MINERALS PROGRAM INSPECTION REPORT
PHONE: (303) 866-3567

MINE NAME: Cresson Project	MINE/PROSPECTING ID#: M-1980-244	MINERAL: Gold	COUNTY: Teller
INSPECTION TYPE: Monitoring	INSPECTOR(S): Timothy A. Cazier	INSP. DATE: March 29, 2018	INSP. TIME: 09:00
OPERATOR: Cripple Creek & Victor Gold Mining Company	OPERATOR REPRESENTATIVE: Justin Bills	TYPE OF OPERATION: 112d-3 - Designated Mining Operation	
REASON FOR INSPECTION: Normal I&E Program	BOND CALCULATION TYPE: None	BOND AMOUNT: \$208,491,188.00	
DATE OF COMPLAINT: NA	POST INSP. CONTACTS: None	JOINT INSP. AGENCY: None	
WEATHER: Cloudy	INSPECTOR'S SIGNATURE: 	SIGNATURE DATE: September 5, 2018

Photo 1. 500-foot leach limit staked out using survey lathe (more stakes beyond).

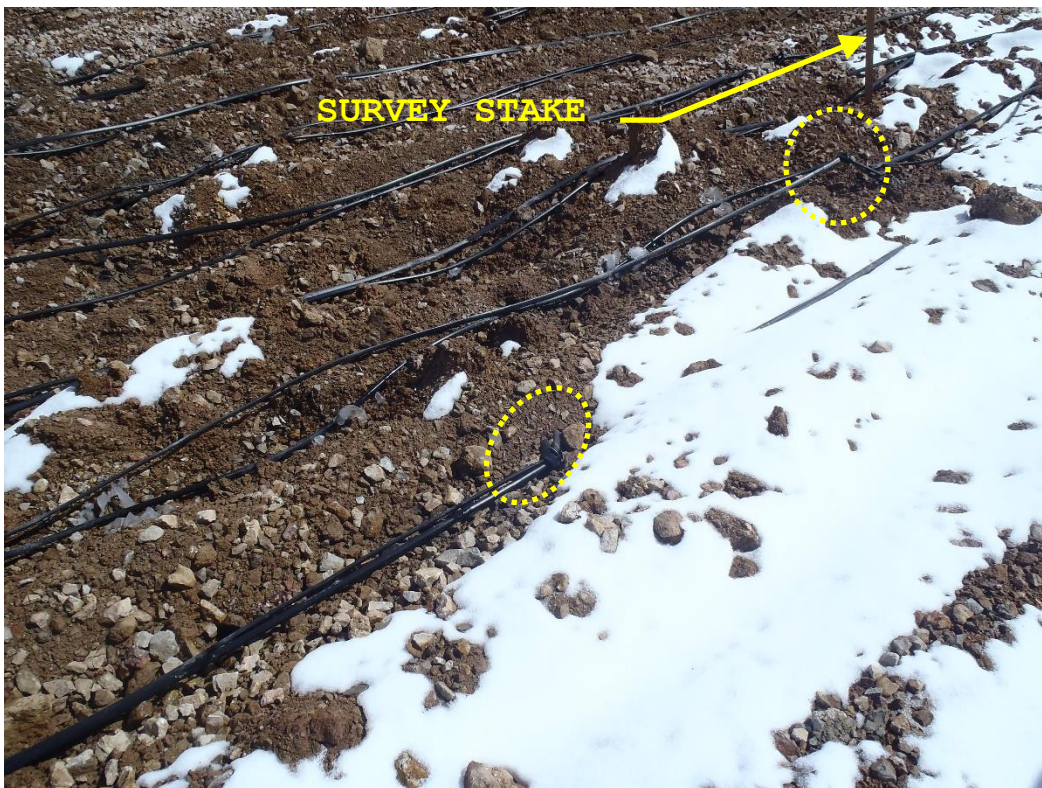
Squaw Gulch Valley Leach Facility (VLF 2) Slide Area: Mr. Jeff Winterton accompanied the Division and Mr. Bills to the area on the east side of the VLF where a slide occurred in December 2017 between the 9850 and 9650 benches. Due to the slide and potential damage (unknown at the time of the inspection) the Division required CC&V to cease leaching within 500 feet of the slide area. The 500-foot limit was observed to be staked out using survey lathe (**Photo 1**) and leach system drip lines were observed to be tied off (**Photo 2**) outside this limit with drip lines dry within the 500-foot limit.
